Environmental Impact Statement on the Construction and Operation of a Proposed Mixed Oxide Fuel Fabrication Facility at the Savannah River Site, South Carolina

Final Report

**U.S. Nuclear Regulatory Commission
Office of Nuclear Material Safety and Safeguards
Washington, DC 20555-0001**

Appendix J includes a summary of the comments and responses received on the DEIS. Ninety-four commenters submitted about 750 comments on the DEIS. Appendix J also identifies changes in the FEIS text based on the comments and revised accident analyses from new design information for the WSB provided by DCS since publication of the DEIS.

Figure 2.2. Principal steps in the fuel fabrication process (Source: DCS 2002).

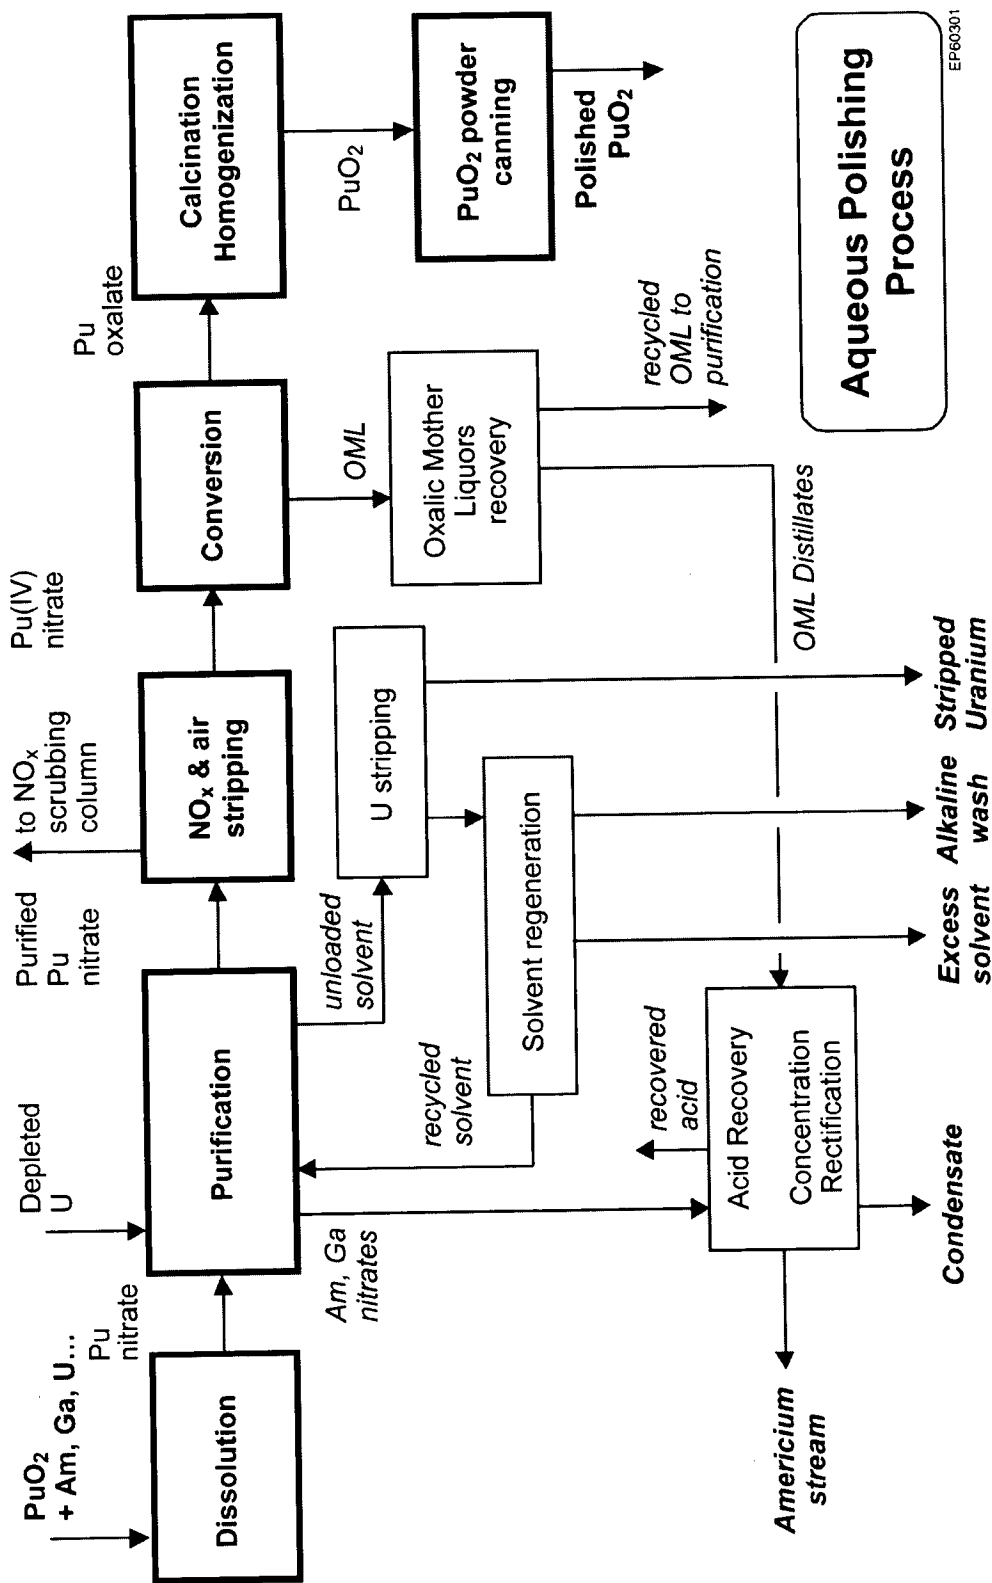
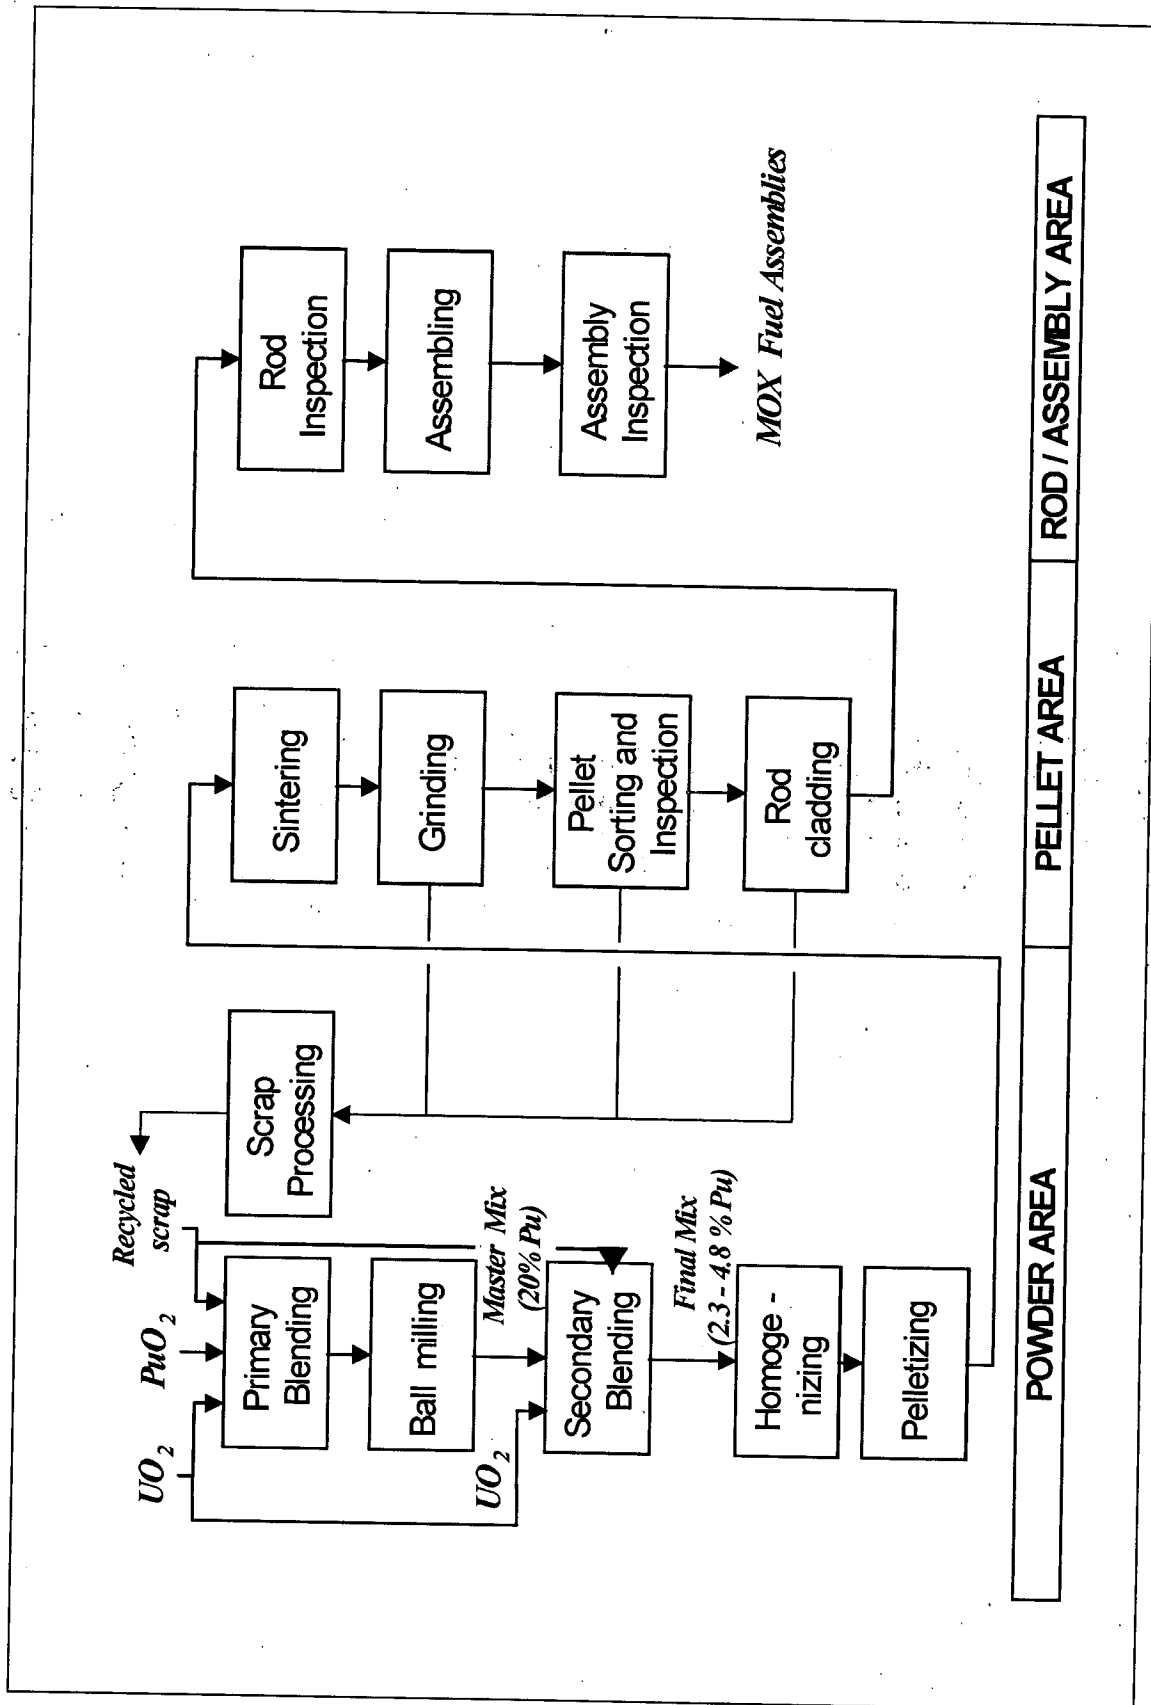
There are numerous process steps in the DOE's MOX plan. Figure 2.2, for example, identifies 13 steps in the Fuel Fabricating Process. The Aqueous Polishing Process has almost as many steps, according to Figure 2.1, however, less than half of them appear to involve plutonium. The PIT Disassembly and Conversion Facility (PDCF) and the Waste Solidification Building (WSB) both have a variety of operations which would take place. Added to all of these processing steps and related activities are those associated with transport between facilities, unloading, loading, and storage as well as the long-distance shipments of uranium and plutonium from seven different locations throughout the country.

Figure 3.2. Locations of principal surface water features at the SRS (Source: DCS 2002).

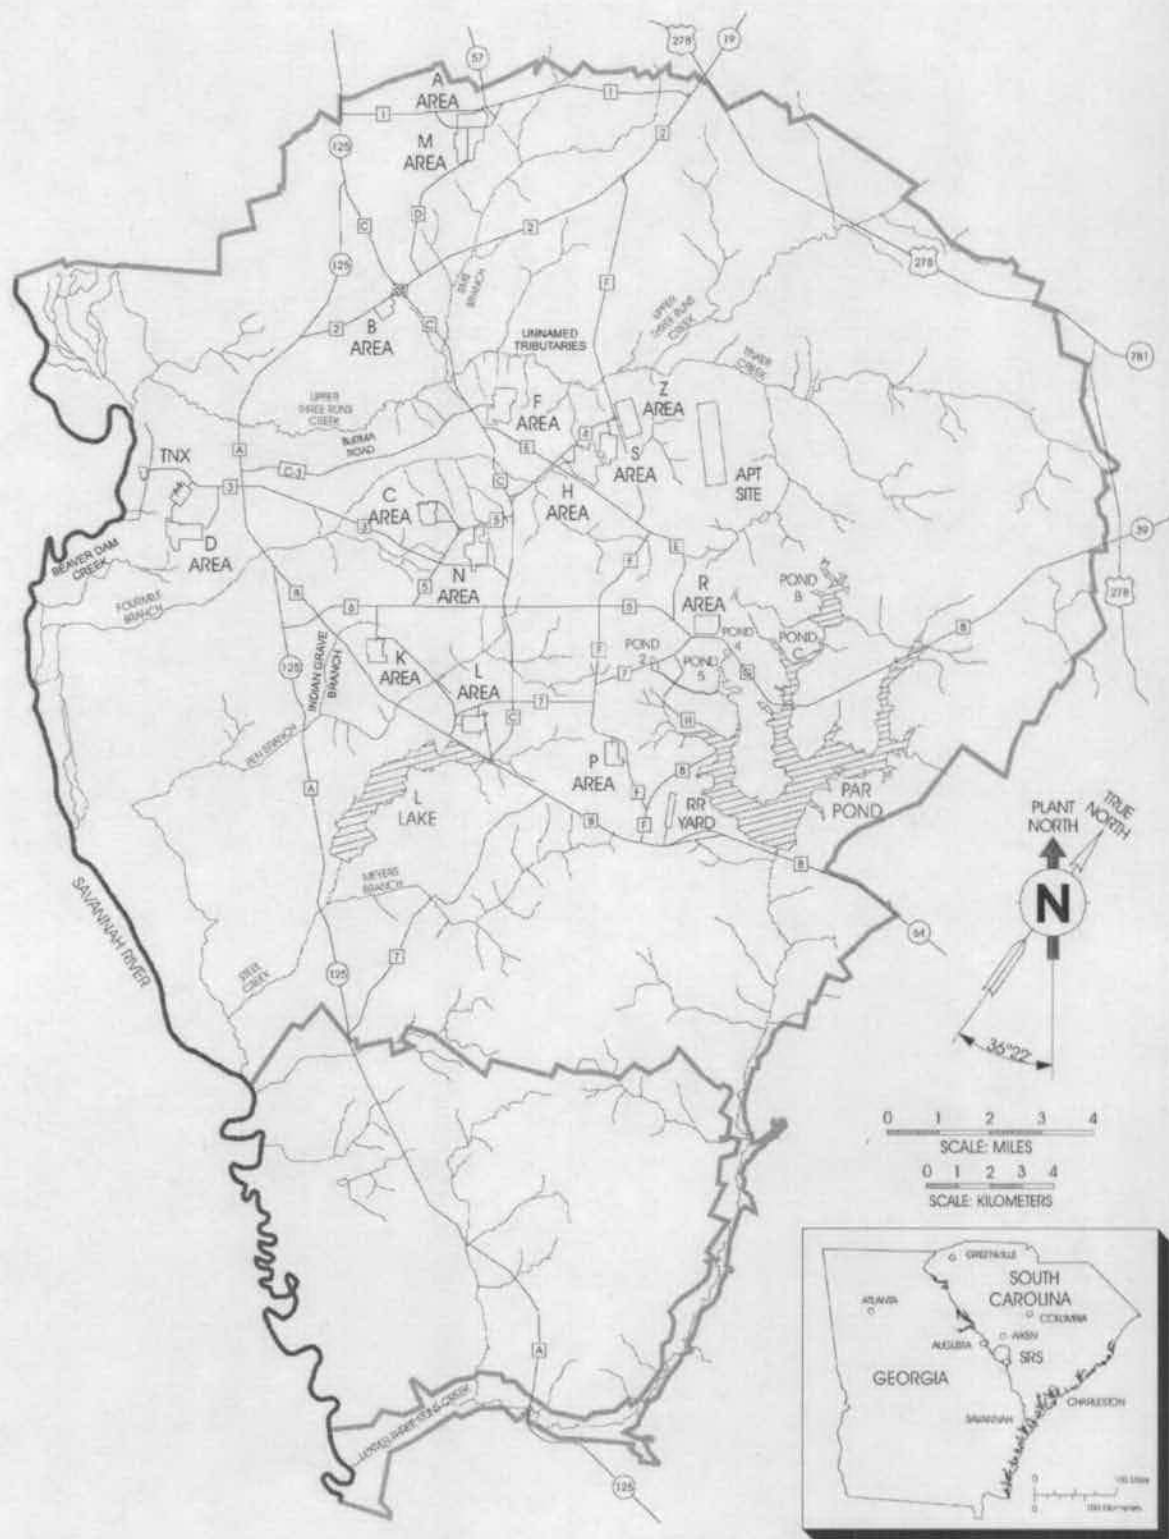
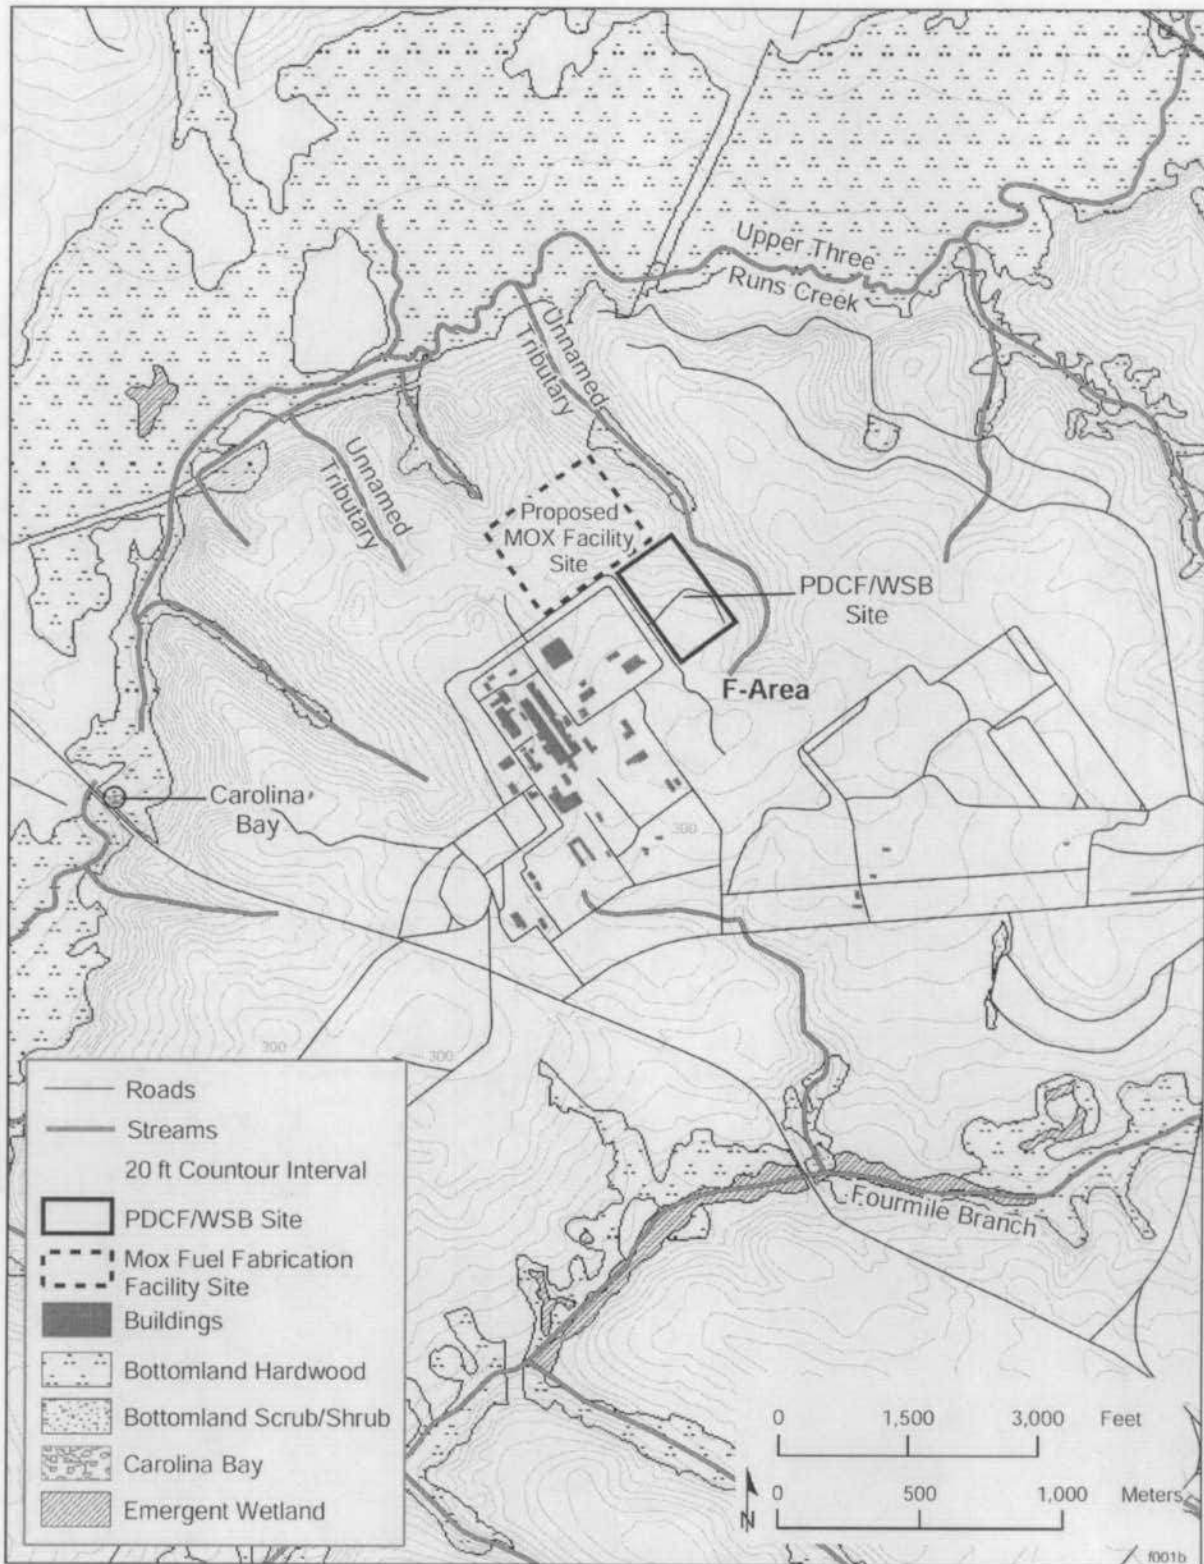
Comment: Fourmile Branch appears to flow southwesterly in Figures 3.2 and 3.3, not southeasterly as described in the text. This apparent discrepancy should be checked and corrected, if warranted.

Figure 3.4. Aquifers at the SRS (Source: DCS 2001a).

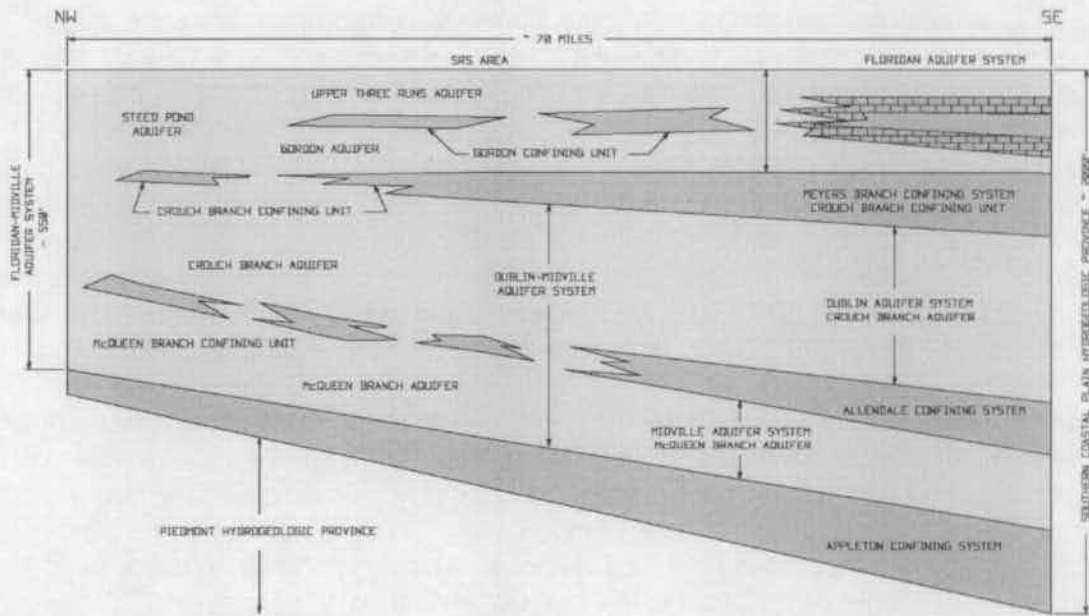
Comment: The discussions in Section 3.3.2 of the DEIS indicate that the Upper Three Runs Creek Aquifer is divided into two zones by the Tan Clay Confining Unit of the Dry Branch Formation. The two zones and the Tan Clay Confining Unit, however, are not depicted in Figure 3.4, "Underground Aquifers at the SRS." Without this information, it is not possible to visualize and understand the groundwater-flow system that underlies the proposed MOX facility. Specifically, it is not clear how the two aquifer zones and the Tan Clay Confining Unit within the Upper Three Runs Aquifer relate to the land-surface topography (outcrop areas), the Gordon Confining Unit, the Gordon Aquifer, and the Steed Pond Aquifer. Figure 3.4 should be redrawn or modified to reflect the text.

Response: Figure 3.4 is a generalized diagram of the groundwater system for the entire Savannah River Site (NW to SE transect). The figure is provided for general, not specific, information. The width of the figure, as shown at the top, is 70 miles. At this scale, F-Area and the location of the proposed MOX facility are not readily distinguishable and accurately splitting the Upper Three Runs Aquifer into two zones is not possible.

Figure 3.5. Annual wind rose for the SRS (Source: Arnett and Mamatey 2000a, Table 31).

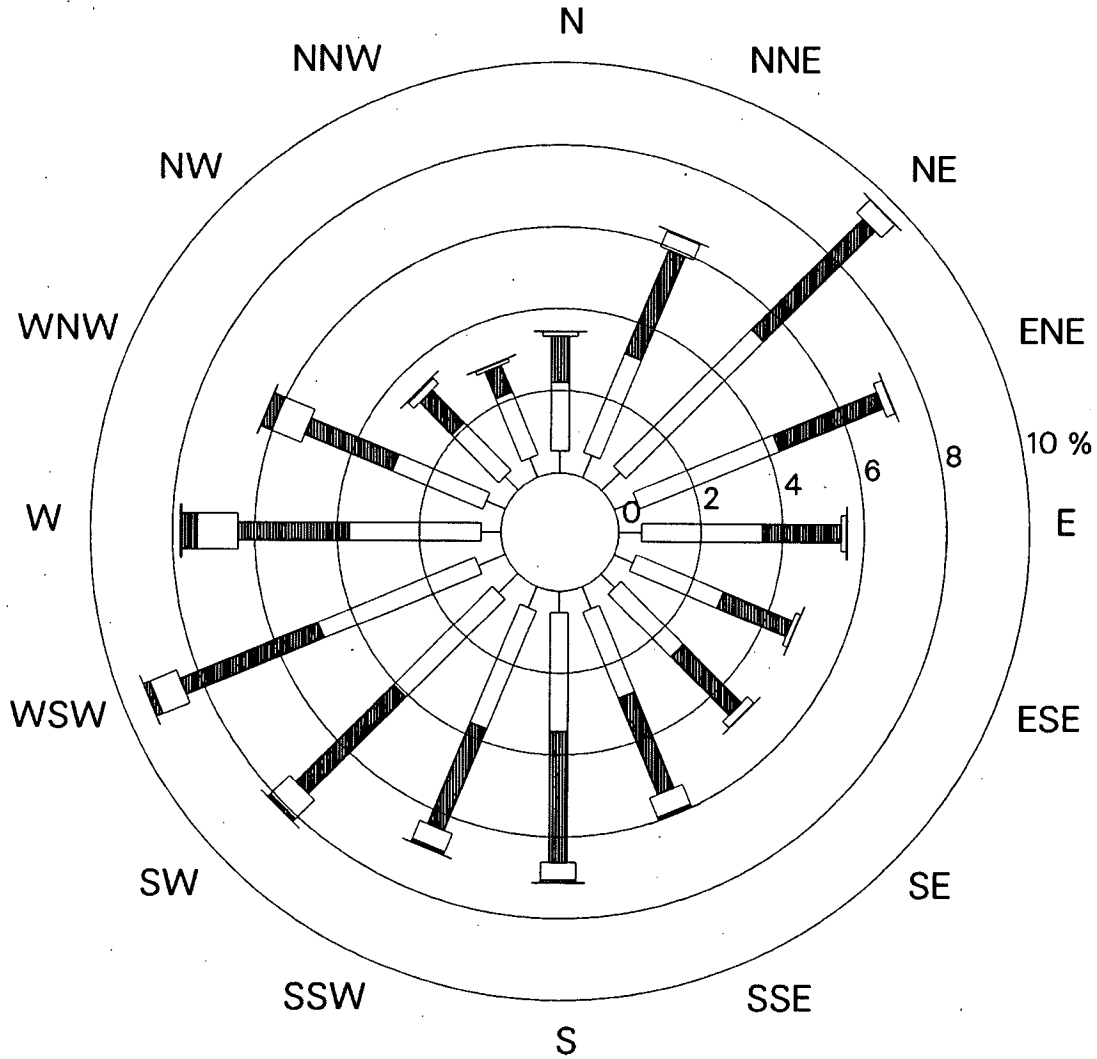
As discussed in Section 4.3.5 of the EIS, impacts from accidents would depend on the wind direction and speed following a hypothetical accident. Figure 3.5 presents the annual wind rose for the SRS. The prevailing wind directions are W to S and NNE to ENE. The least prevalent wind direction is to the N and NW. The SRS emergency response plan takes into account the prevailing wind direction at the time of an accident.

Response: Five years of data are frequently used to provide an overall picture of wind speed and direction. EIS Figure 3.5 presents such data. Five years of data are also suggested by the U.S. Environmental Protection Agency as the basis for dispersion modeling. Thus, the data set used is deemed adequate.
